**6675A-09A**

**S E R V I C E N O T E**

**6675A DC POWER SUPPLY GPIB CONTROLLED**

**The Current Shunt (Circuit Reference “R907”) may have intermittent sense wires, which may cause Instability of Current regulation, Current read back and current programming.**

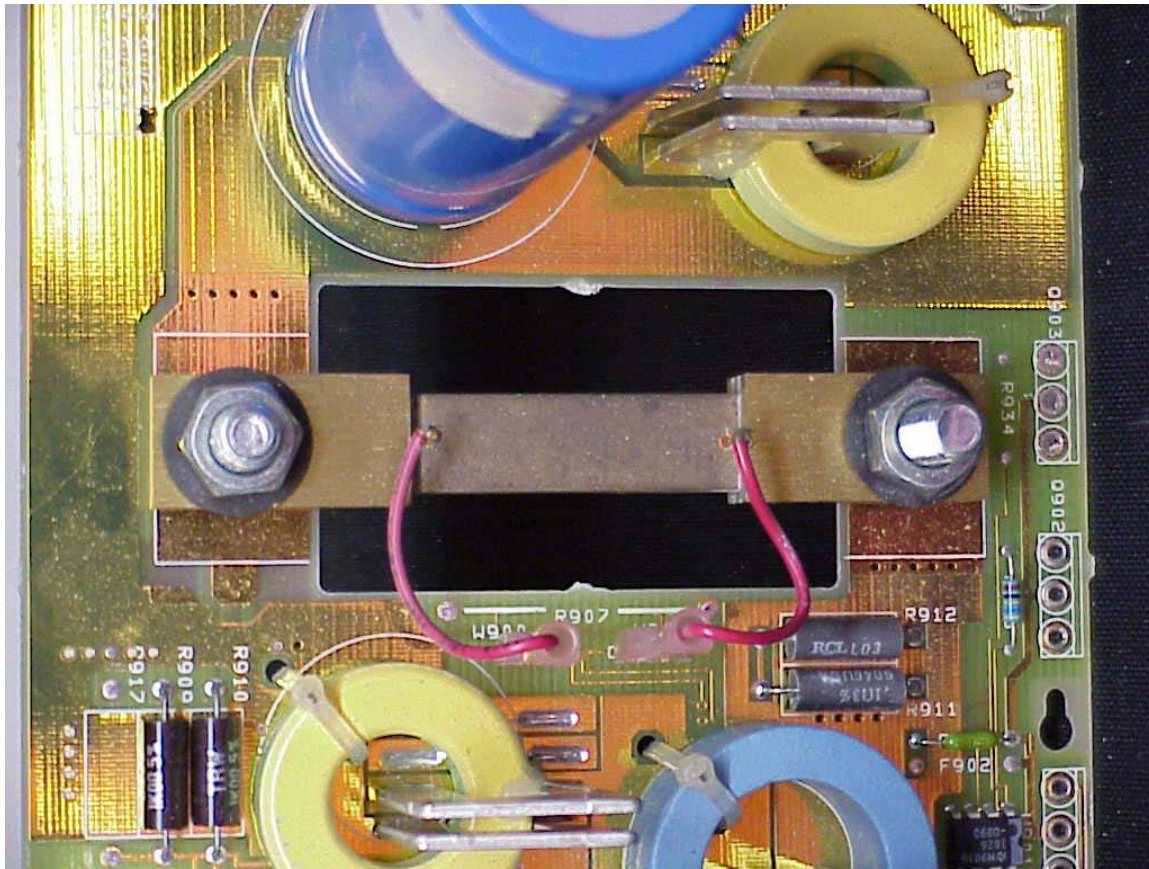
This picture shows how the Shunt R907 is connected using the term-crimp connectors.

The Shunt R907 is connected to "W900" & "W901"

Cut the terminal-crimp connectors off of both wires and discard the connectors. Make this cut as close to the terminal-crimp connector as possible. The required strip length should be 5mm. This strip length will be used to prevent the wire length being too long and shorting to the instrument chassis. If replacement of this wire is required any color (22 AWG, 300V 105C) wire type can be used.

This modification can be done from the top of the board. Carefully strip and solder the wires, and avoid burning the wire insulation and the printed circuit board.

The wires should be connected as shown below. There are two holes marked R907 that should be used. Do not cross the wires when making this modification. See picture below for details. This picture shows the required modification.
